12-14. WRE AND LEACHATE DAM

This concern responds to the following SEARs for SSD 5765:

Figure 1: WRE plan showing 5 m elevation contours. Source – adapted from DSK-1002 (Advisian, 2020, p. 35)

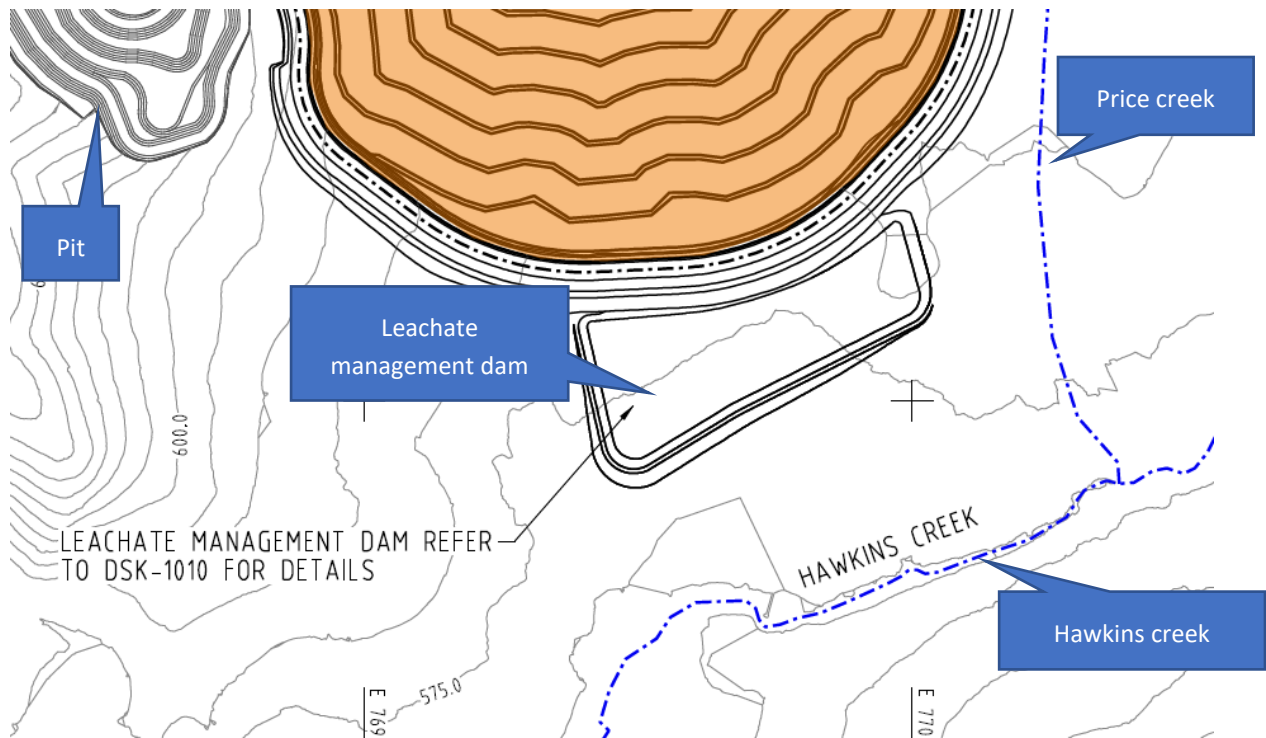
Figure 1 shows the relative size of the WRE next to the planned pit and its proximity to Price Creek. Figure 2 shows there is 1 m of planned freeboard to prevent overflow into Hawkins and Price Creeks. Figure 3 shows

Figure 2: Maximum storage level and freeboard at the south of the leachate management dam. Source – adapted from DSK-1010 (Advisian, 2020, p. 43)

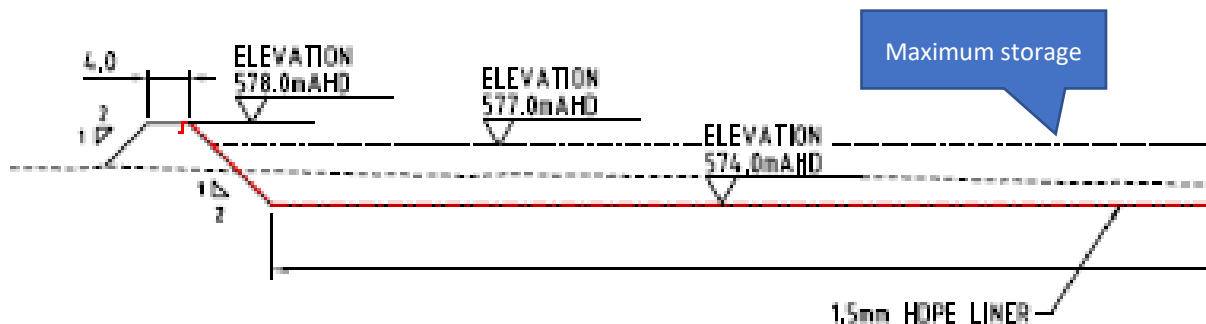
Leachate from the dam is planned to be pumped to the 'in-pit dewatering sump' or 'dewatering pond' if water levels reach 577 mAHD (R.W. Corkery and Co. Pty Limited, 2020). The design pumping capacity is not stated and it is unclear whether this infrastructure will exist post mine closure as leachate continues to enter the dam. Furthermore, no evidence is presented that HDPE 1.5 mm lining can withstand low pH leachate for hundreds of years beneath the PAF WREs. No detailed contingency plans for remediation post mine closure are described in the EIS and no 'success criteria' refer to a lack of leakage into the aquifer (R.W. Corkery and Co. Pty Limited, 2020, pp. A5-67).

Figure 3: Mapped faults in the area of the planned WRE and leachate management dam. Source – adapted from Figure 11 of (Jacobs (Australia), 2020, pp. 5-57)

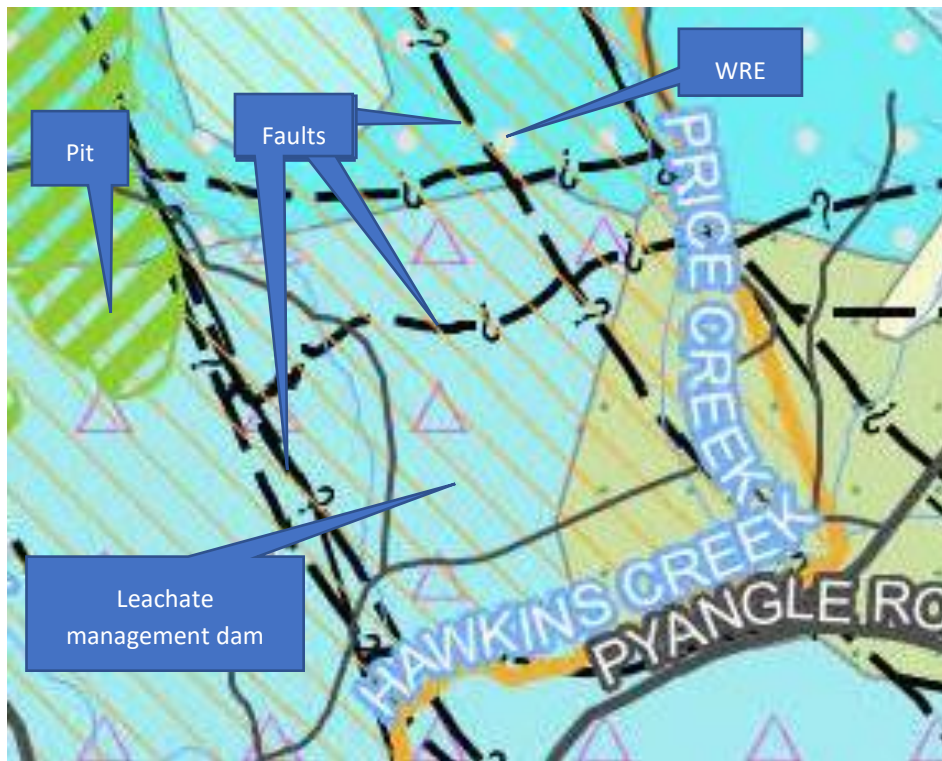
the presence of faults around and under the WRE and leachate management dam that have not been considered in the designs.
